PLANNING DEPARTMENT
Staff Report & Recommendation

Design Review Board

SUBJECT: DRB18-0354

500 Alton Road, 630 Alton Road, 650 Alton Road, 1220 6th Street, 659-737 West Avenue

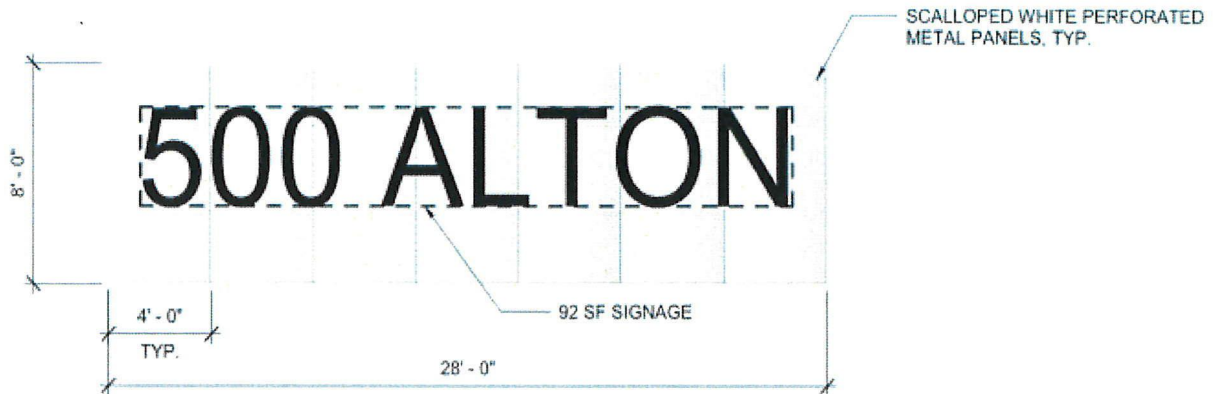
The applicant is proposing four monument signs at each of the more prominent corner intersections of the multiblock site: the northeast corner of 5th Street and West Avenue, the southeast corner of 6th Street and West Avenue, the southwest corner of 6th Street and Alton Road integrated with a water feature, and the northwest corner of 6th Street and Alton Road. As designed, the four structures are proposed as simple address lettering, individually mounted on a 8'-0" high wall made of perforated metal panels seemingly to create a clear distinction between public and private property. The design of the address signs blocks the view corridors and building entrances with a clear line of sight from both inside and outside.

Additionally, Section 138-19 allows for the monument signs to be permitted higher than 5'-0" and up to 10'-0" from grade when reviewed through the design review process. Staff has concluded that the hardship and practical difficulty criteria have not been met and that the overall design detail and materials proposed do not warrant the increased size **or height**.

Staff would be supportive of the address signs if the design is modified to better reflect the signage illustrated in the above previous submittal's rendering (sheet A4-06), which demonstrates a more artistic approach to signage and is a more proper design that effectively uses the built environment as a natural surveillance to eliminate blind spots or hiding areas that would be a result of an 10'-0" barrier-like wall sign. This rendering is provided for illustration purposes only, as subsequent plans do not detail such signage. Staff recommends denial of the variances pertaining to the size of the signage (#8-11). Staff also recommends that any monument sign be limited to 5'-0" in height.

Retail pavilion with park plaza edge condition (no parking/no drives)

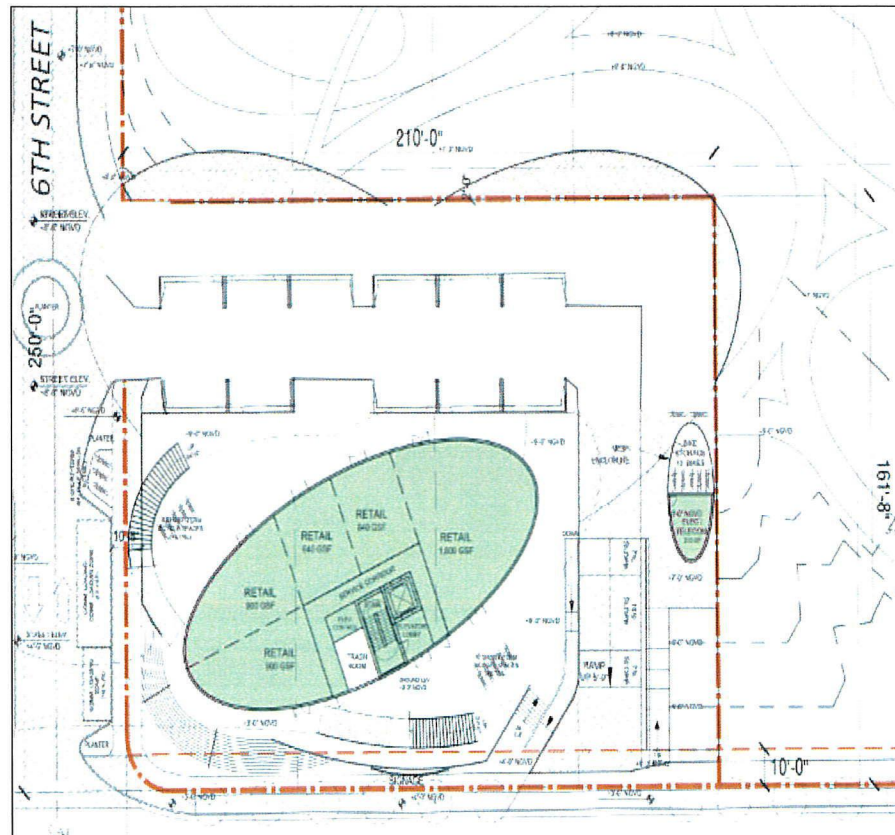
Staff firmly believes that the introduction of the surface parking lot prevents the retail pavilion from being able to fully integrate, engage and provide activation for the park space, as it creates a physical barrier in the form of a suburban- strip mall parking lot. Even new construction of buildings, citywide, does not emulate failed suburban models such as this. As the proposed park is within an urban area, with a fully defined street and sidewalk grid, its design should reflect its setting. The following diagram illustrates how superior this engagement of the park could be, simply by removing the unnecessary parking lot:
